FINAL
MONITORING REPORT
YEAR 3 (2020)
MUD LICK CREEK MITIGATION SITE

RE: Mud Lick Creek Monitoring (DMS Project # 93482, Contract #7683)
Final MY3 (2020) Annual Monitoring Report

Axiom Environmental, Inc. (AXE) is pleased to provide you with one hard copy and a CD of digital files for the Final Mud Lick Creek MY3 (2020) Annual Monitoring Report. We received your comments via email on December 18, 2020 and have addressed them as follows:

FIGURE
2

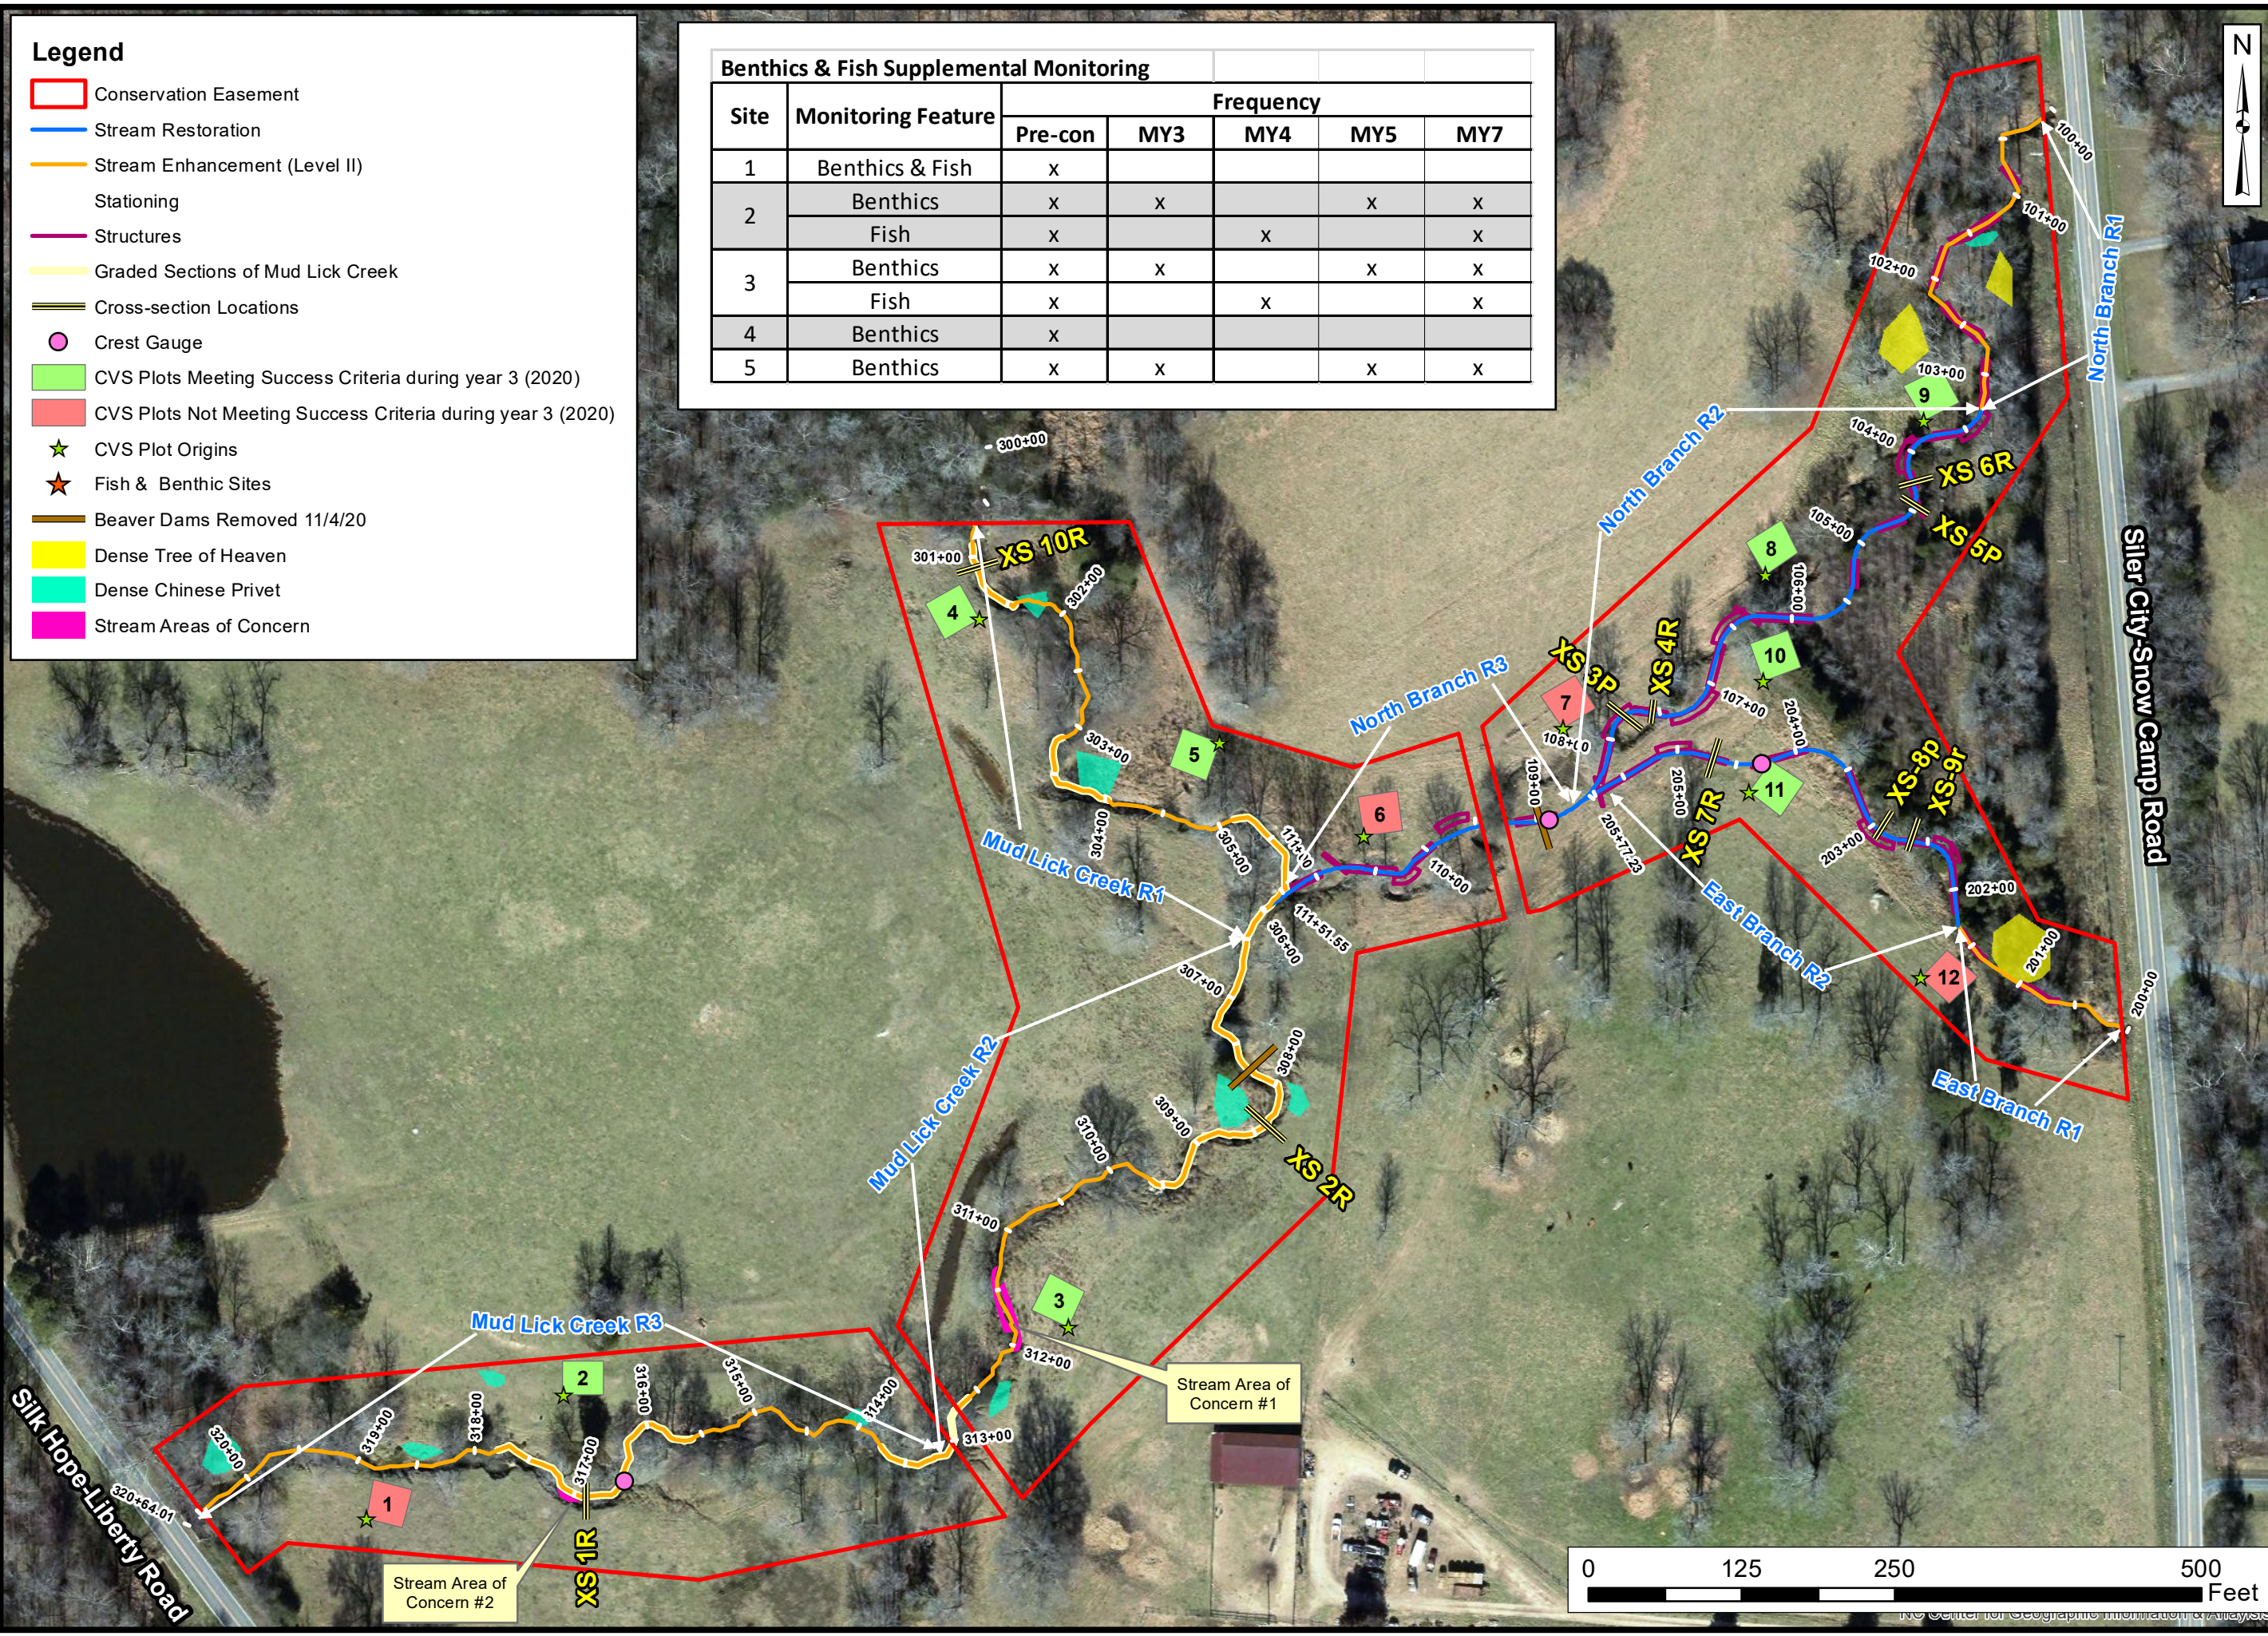
1. Please verify the restoration reaches that had bankfull events. Was it both restoration reaches that had bankfull events in 2019 and 2020?
Table 12 was updated to indicate where wrack, etc. was observed and which crest gauges indicated bankfull events. For all events documented in 2019 and 2020, all crest gauges indicated a bankfull event had occurred even when other indicators were observed only on individual reaches.
2. Please add a brief discussion of the beaver activity observed in the Visual Assessment section and include that the beavers were trapped and the six dams removed by the USDA on November 4
A brief discussion of beaver management activities was included in the "Project Boundaries & Visual Assessments" section of the report.
3. Please add removed beaver dam location to the Figure 2 CCPV.
The locations of the 2 larger removed dams were included on Figure 2.
